**Application Number & Location:22-1068 RRM.docx**

**Proposal: Reserved Matters application pursuant to Condition 4 for the Formal Park (Phase 3b) and the erection of a Church Hall attached to the Garrison Church of St Barbara (Phase 3d) with access, layout, scale, appearance and landscaping being considered and the partial submission of details pursuant to conditions 16 (Ecological Mitigation and Management), 21 (LAP's and LEAPs), 29 (Tree Retention and Protection), 32 (Hard and Soft Landscaping) and 33 (Landscape Management Plan) attached to 12/0546 as amended by 18/0619 and 18/1002 and Schedules 5 Part 10 (formal park) and 9 Part 9 (LEAPS and LAPS) of the Section 106 agreement dated 17 April 2014 as varied.**

**Date:17/11/22**

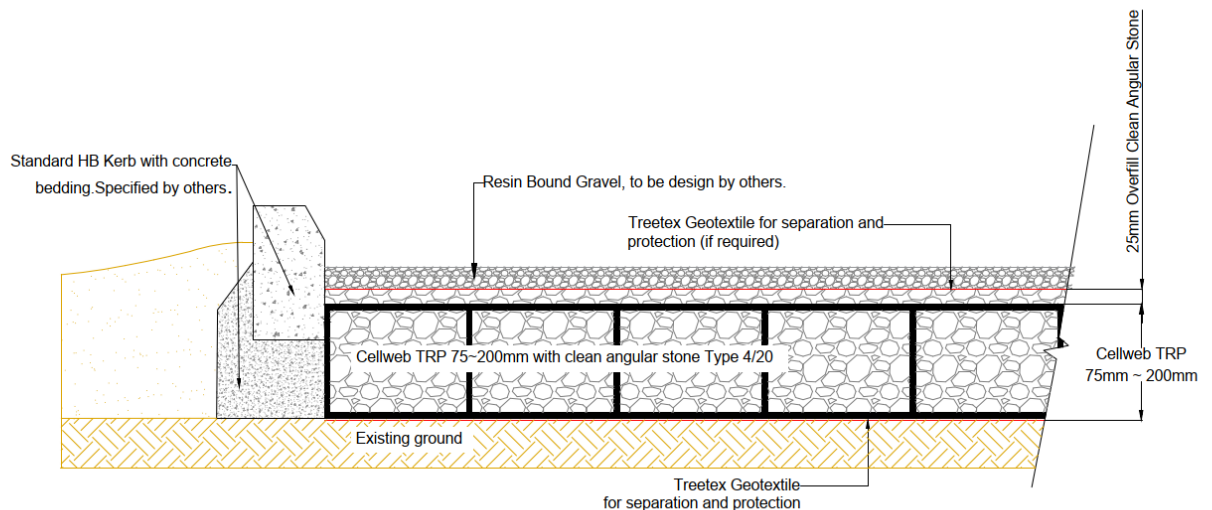
- Appendix C4 relates to Excavation Under Supervision not CCS. There is a cross-sectional diagram of the CCS within appendix C5. This is generic and not site specific, it should include any areas that are not built to the specification within the generic design, for example the resin bound surface generally requires an overfill and a porous asphalt wearing course to support the resin bound surface, this is why we ask for a site specific cross sectional drawings of the CCS, there should also be a

- Geo-synthetics the leading supplier of CCS does not recommend a geotextile between the wearing course and gravel, the geotextile is located between the ground and the gravel instead. This helps to prevent the porosity of the wearing course from decreasing over time. My comment has been misunderstood, the second geotextile should be between the cells/overburden and before the sand/gravel/asphalt, to prevent interstitial fill over time, details below. Highlighted in red on the cross section below.

Please provide more details around 'the sub base' generally a CCS does not require a sub base and the CCS laid directly onto the geotextile. If this is in error then please remove and update.

- Appendix C5 will be updated to show the wearing course and means of enclosure.
- There will need to be a geotextile layer between the CCS and the wearing base course/gravel.

- We will remove Point 3 from the methodology within Appendix C5. I will await this change, thanks.
- Point 12, concrete shall not be used as it is not porous, please remove, please provide the exact wearing course proposed on the plans and in the AMS.
- Porous concrete is a recommended wearing course as specified by Geo-synthetics but point 12 will be updated to provide the specific wearing course of porous resin bound gravel – please also include the laying base for porous resin bound gravel (if proposed)
- If any of areas are block paving as a wearing course it will need to be jet washed to remove residual debris. If gravel then as proposed is acceptable, more details around wearing courses is required.
- Porous resin bound gravel will be used as the wearing course.
